DEVELOPMENT REVIEW COMMITTEE MEETING - JUNO SQUARE RESIDENTIAL (2ND MEETING)

Development Review Committee Comments Planning and Zoning

Re: The Dunes at Juno Beach (formerly known as Juno Square Residential) Second Development Review Committee - Site Plan Review and Special Exception Application

TASK:
**PRELIMINARY
WATER & SEWER PLAN**

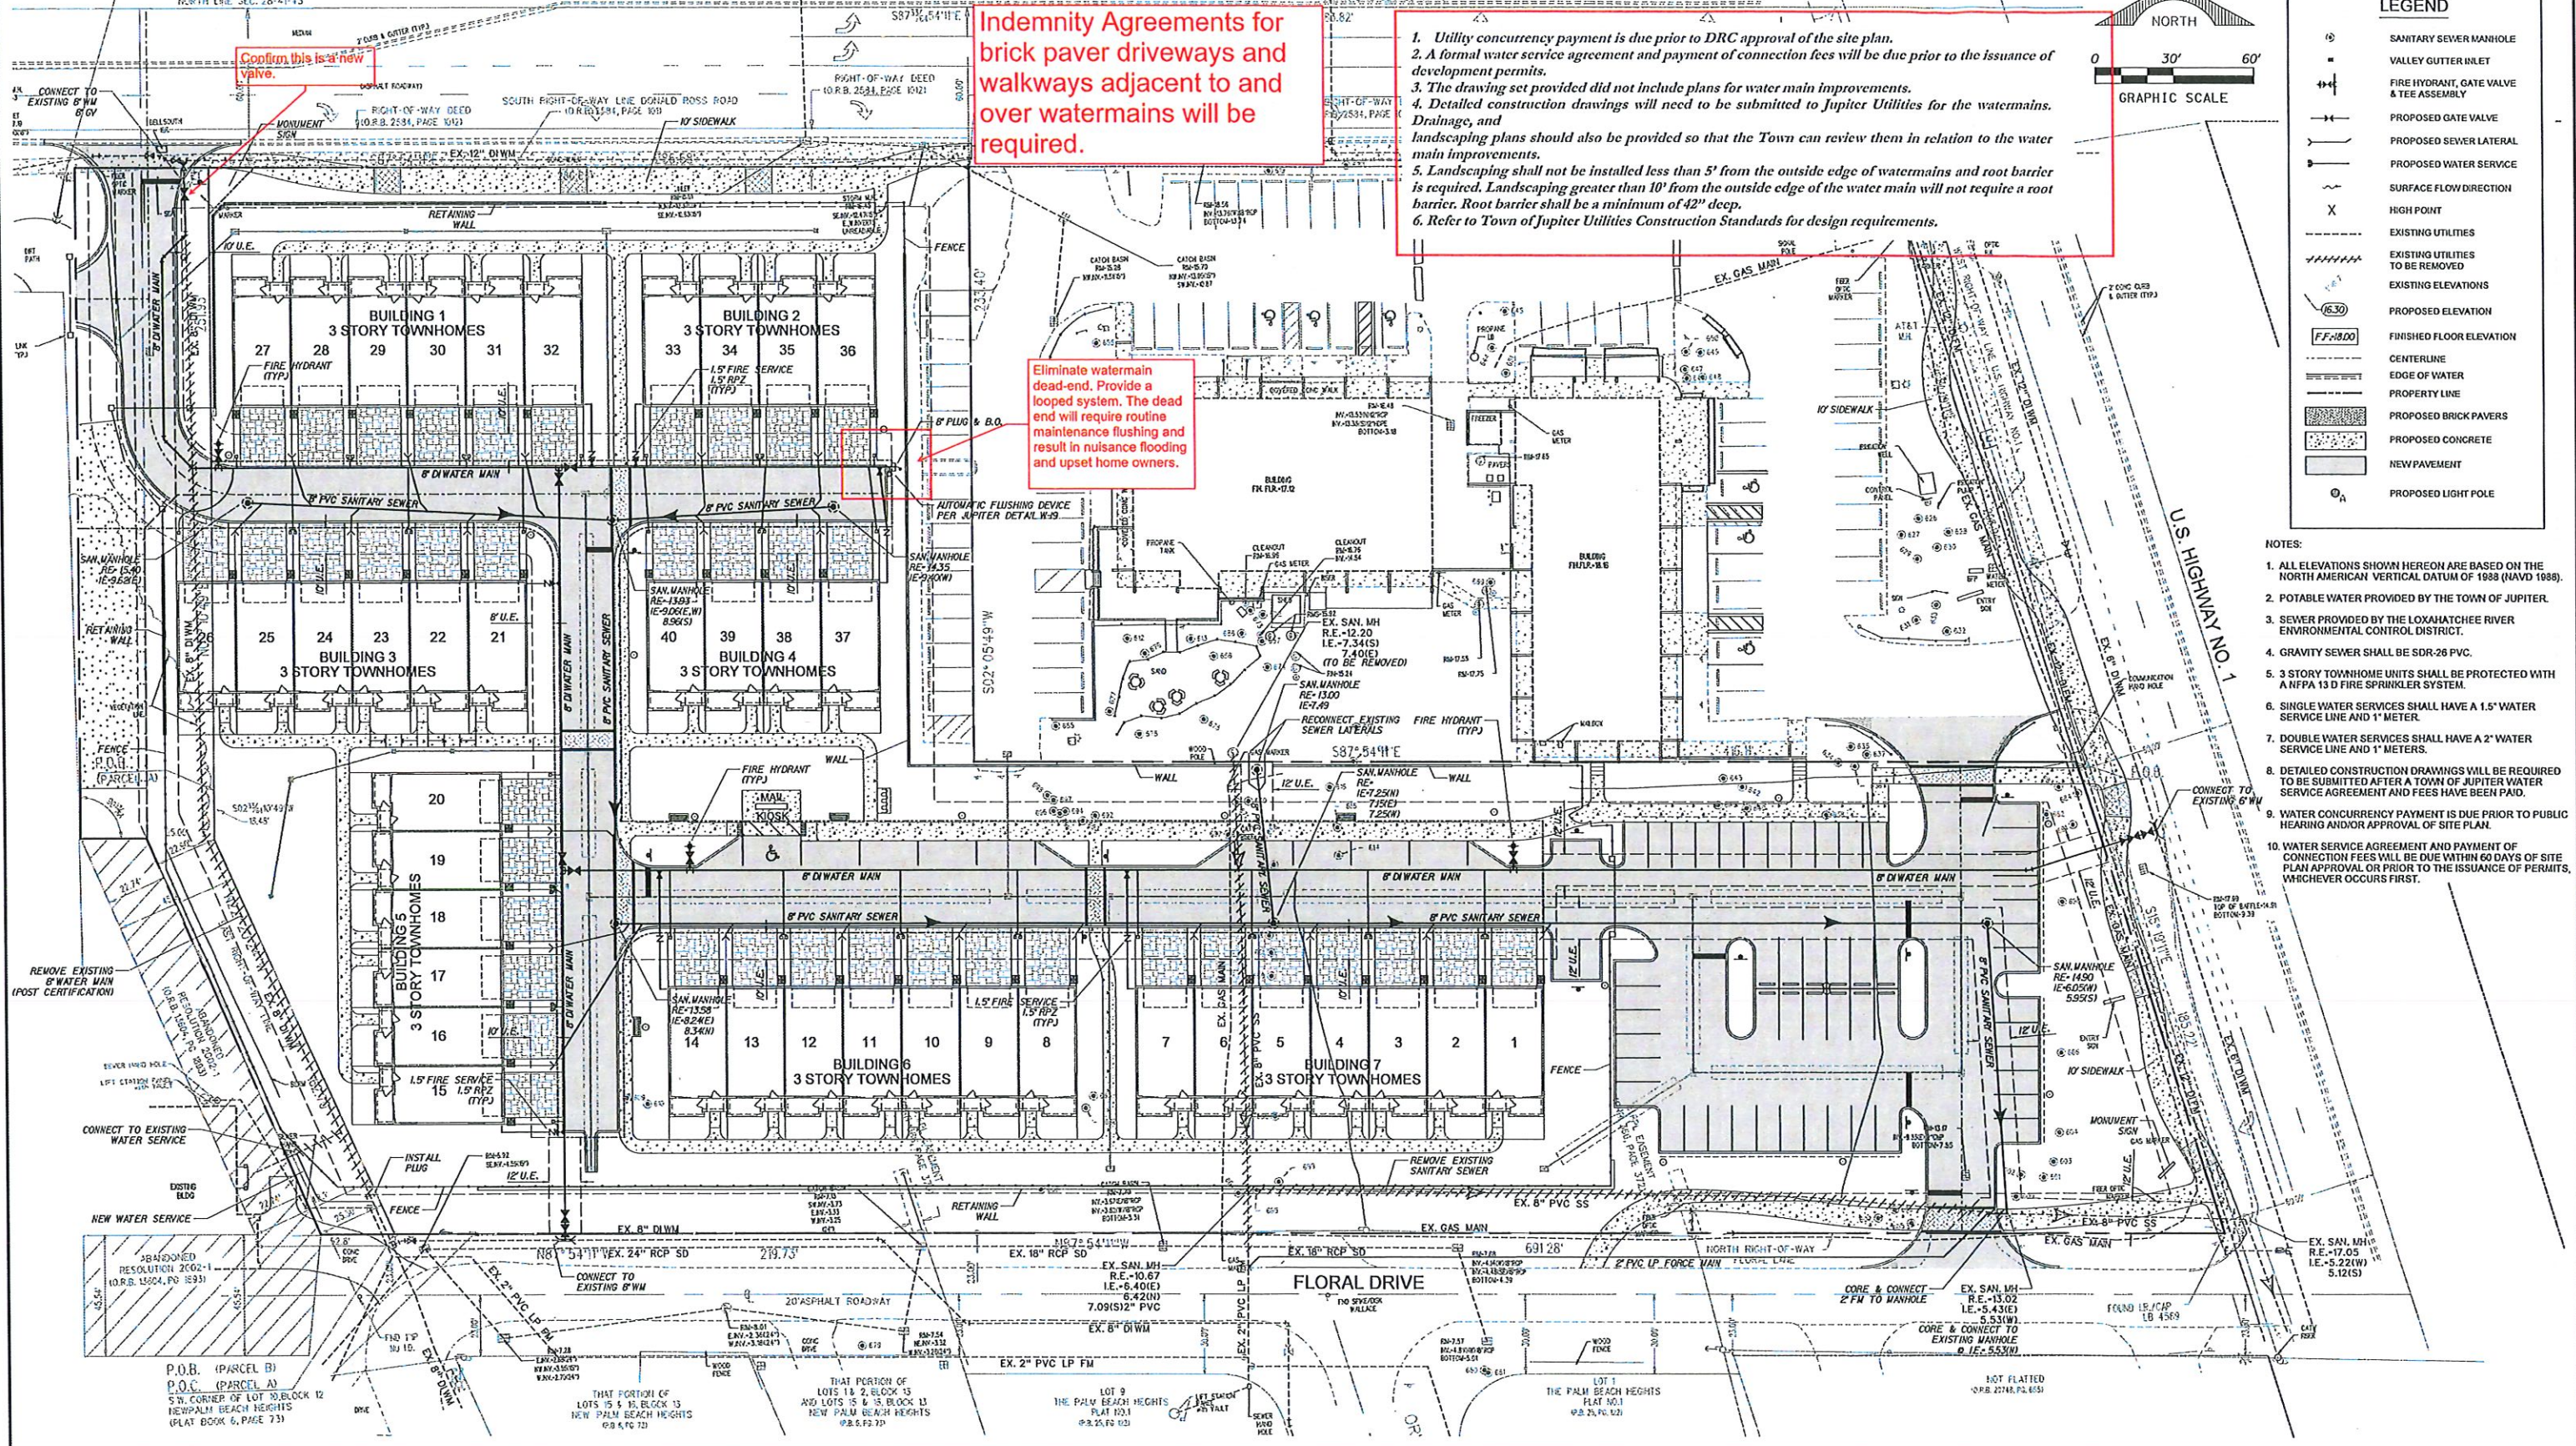
- WATER CONCURRENCY PAYMENT IS DUE PRIOR TO PUBLIC HEARING AND/OR APPROVAL OF SITE PLAN.
 - WATER SERVICE AGREEMENT AND PAYMENT OF CONNECTION FEES WILL BE DUE WITHIN 60 DAYS OF SITE PLAN APPROVAL OR PRIOR TO THE ISSUANCE OF PERMITS, WHICHEVER OCCURS FIRST.

Indemnity Agreements for brick paver driveways and walkways adjacent to and over watermains will be required.

- Utility concurrency payment is due prior to DRC approval of the site plan.
- A formal water service agreement and payment of connection fees will be due prior to the issuance of development permits.
- The drawing set provided did not include plans for water main improvements.
- Detailed construction drawings will need to be submitted to Jupiter Utilities for the watermains. Drainage, and landscaping plans should also be provided so that the Town can review them in relation to the water main improvements.
- Landscaping shall not be installed less than 5' from the outside edge of watermains and root barrier is required. Landscaping greater than 10' from the outside edge of the water main will not require a root barrier. Root barrier shall be a minimum of 42" deep.
- Refer to Town of Jupiter Utilities Construction Standards for design requirements.

Eliminate watermain dead-end. Provide a looped system. The dead end will require routine maintenance flushing and result in nuisance flooding and upset home owners.

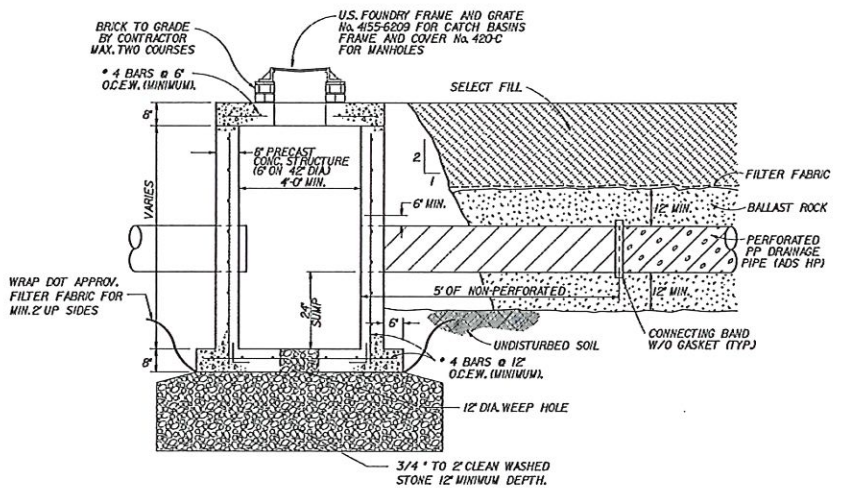
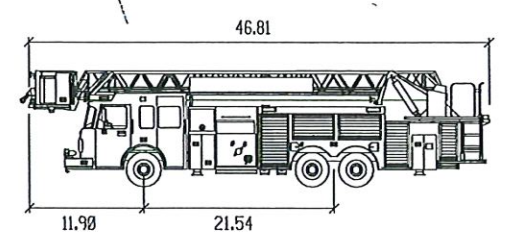
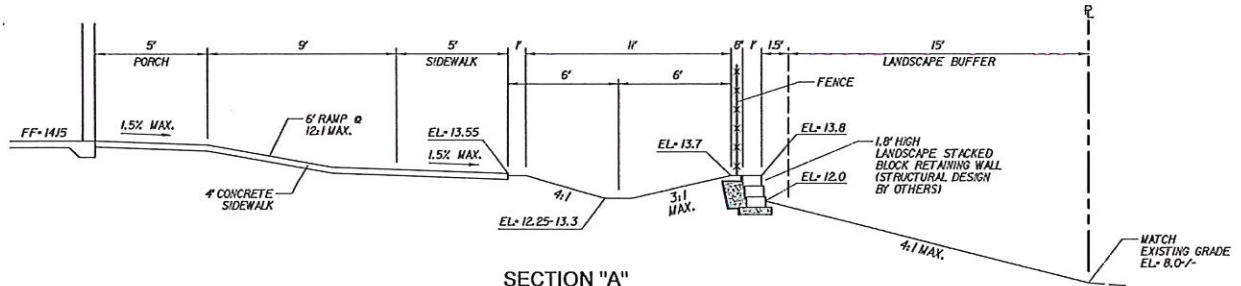
Add Town of Jupiter Water System Standard Details.

MFPD 100' Aerial Platform Pierce Arrow XT

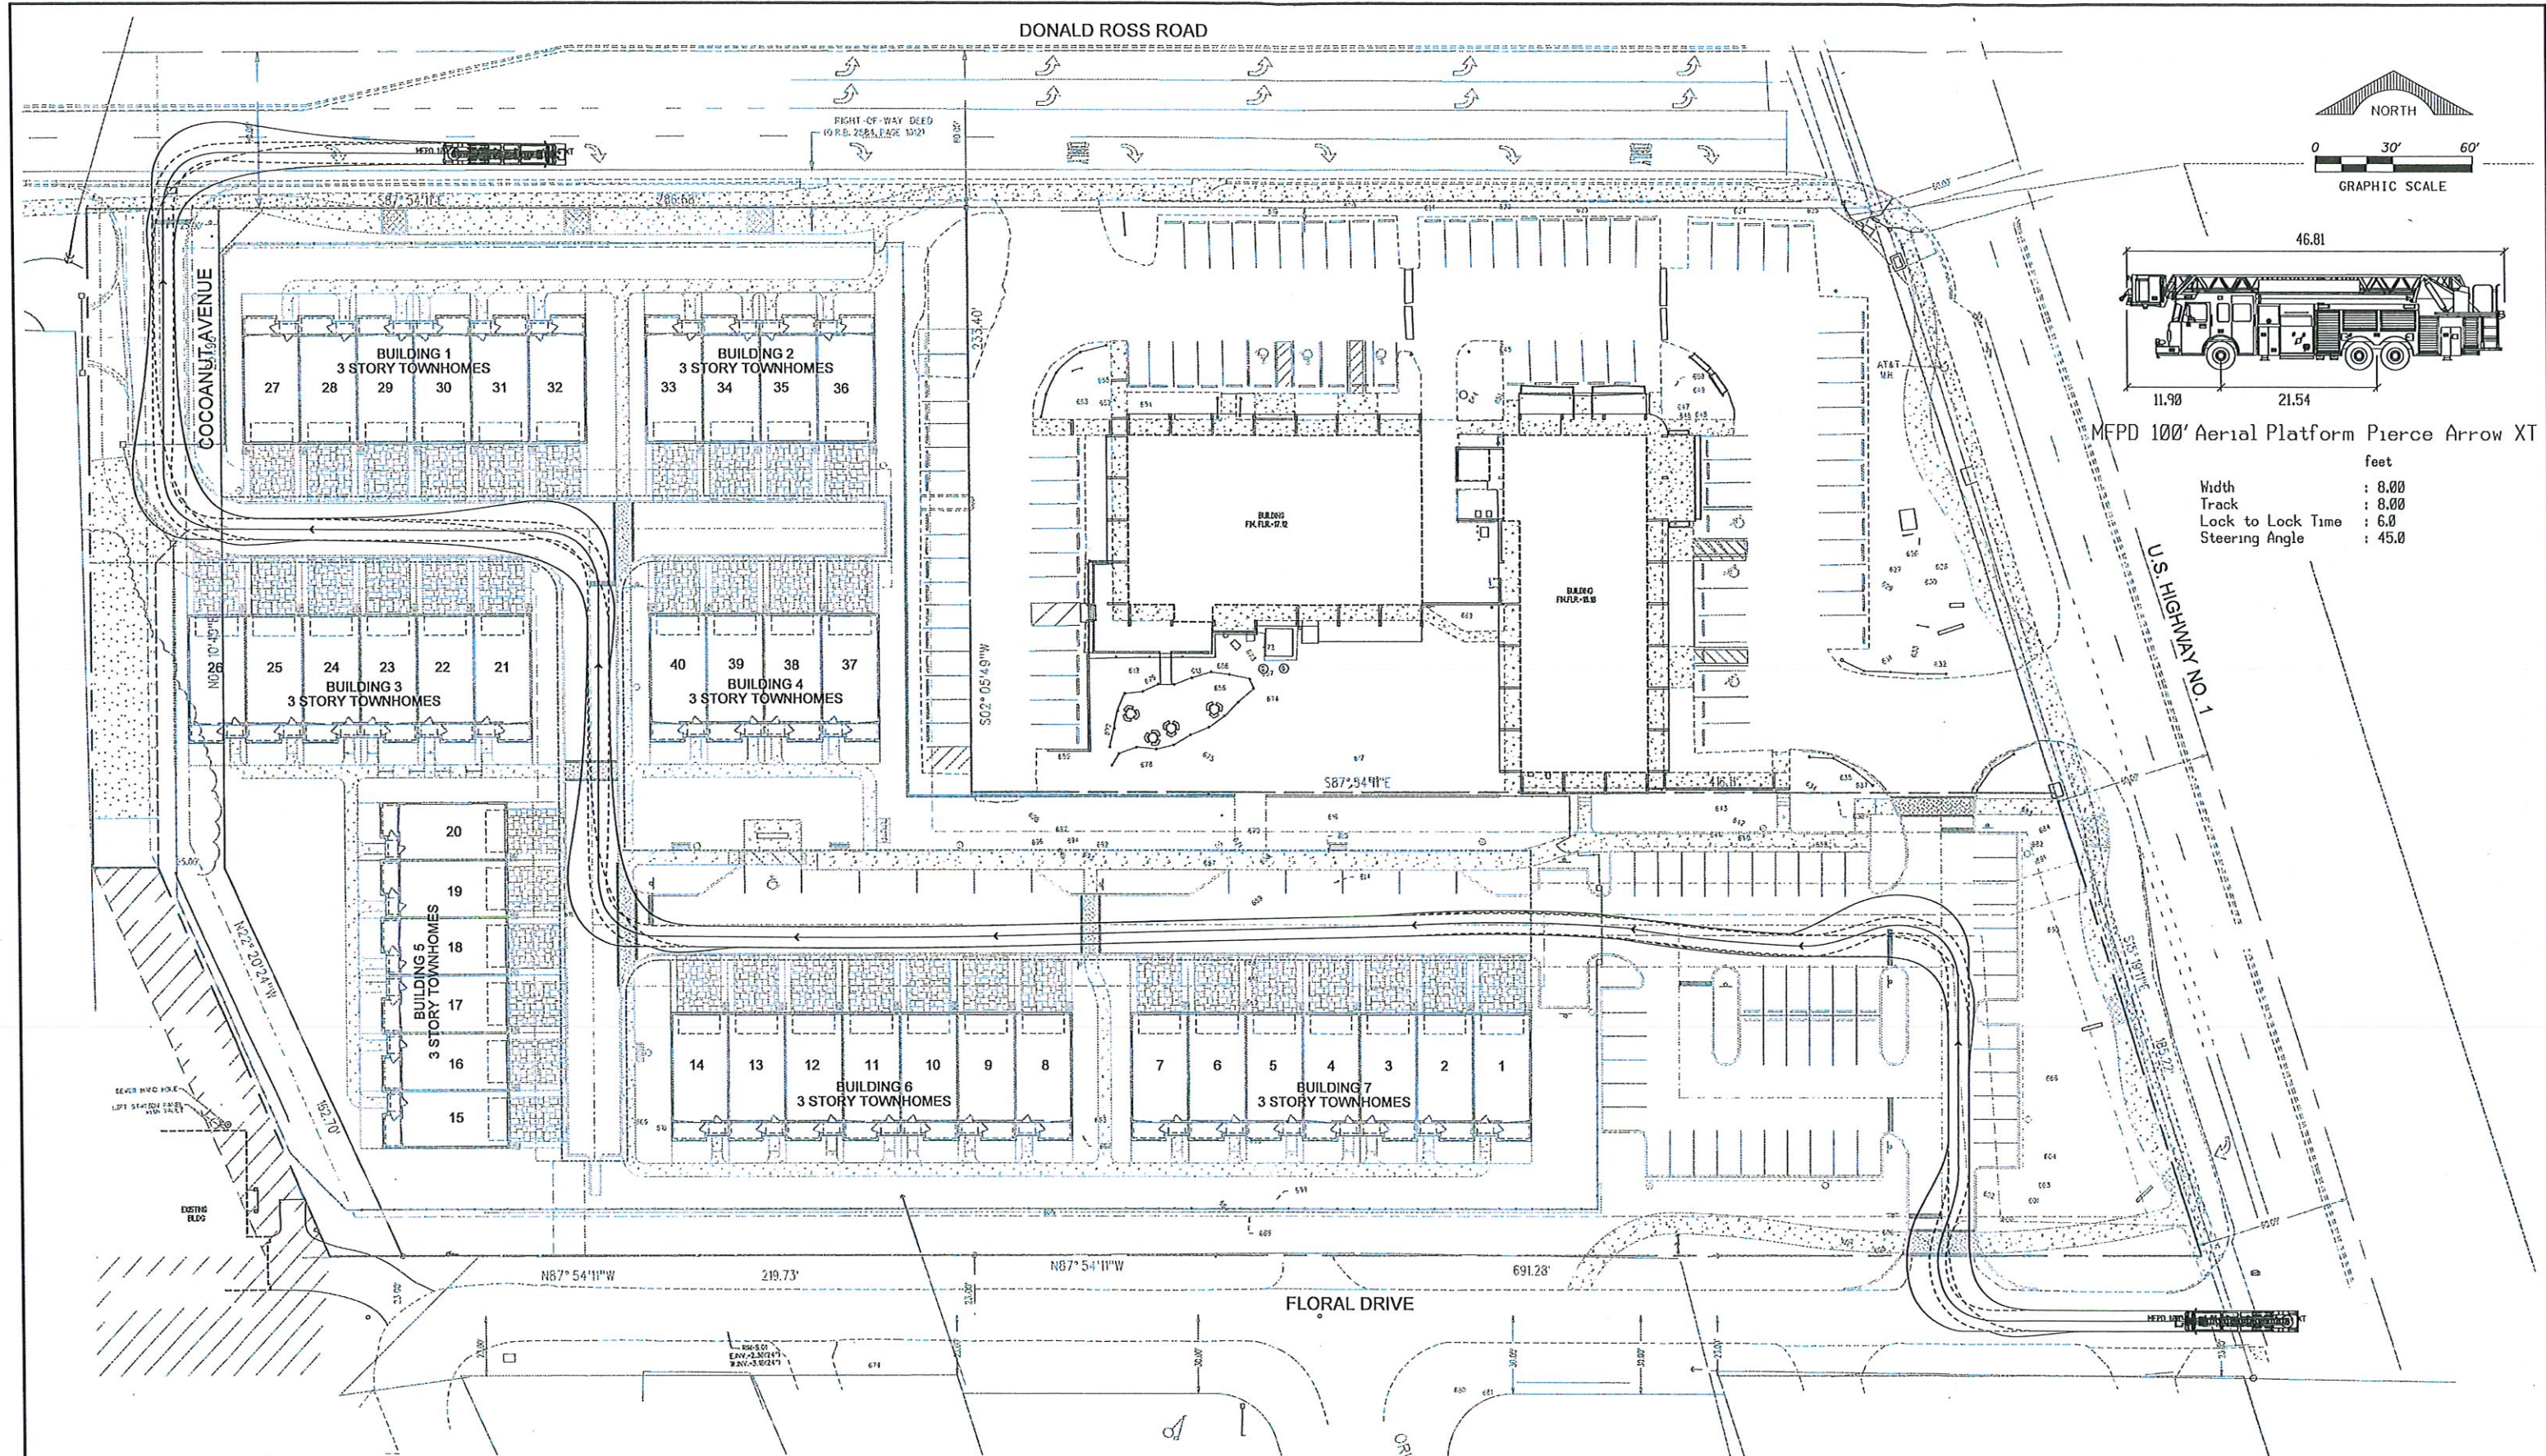
Comment: The fire truck appears to be running over a section of gate in the provided AutoTurn plans. Additionally, a garbage truck AutoTurn was not provided.
